Package 7 - Level 6

Date: Aug 9/15

PROJECT NAME: SQ ALEXANDRA PARK - BLOCK11

DRAWING TITLE: 6th FLOOR KEY PLAN

DRAWING No.:
E6-22

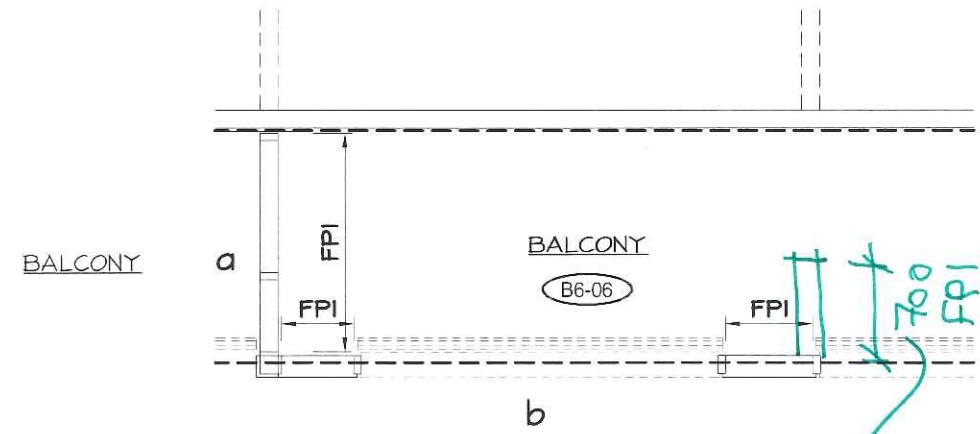
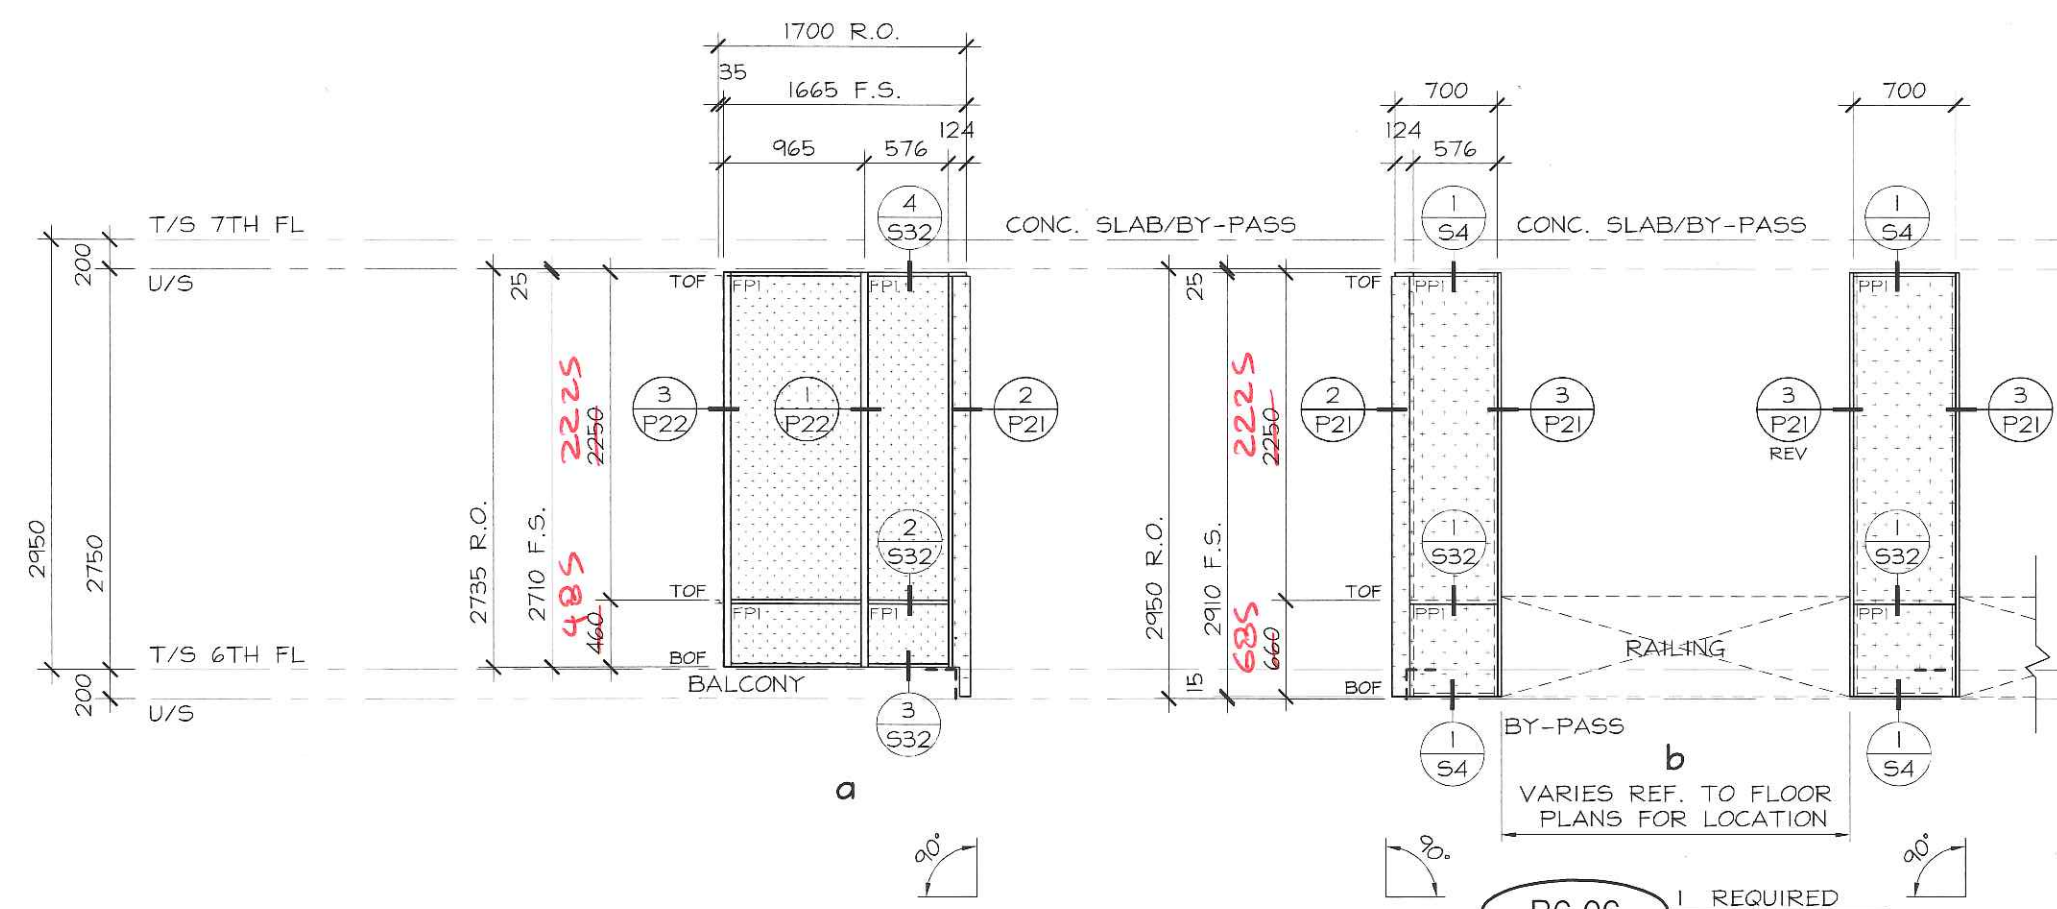
same C Panel
@ B6-04
Dwg. No. E6-21
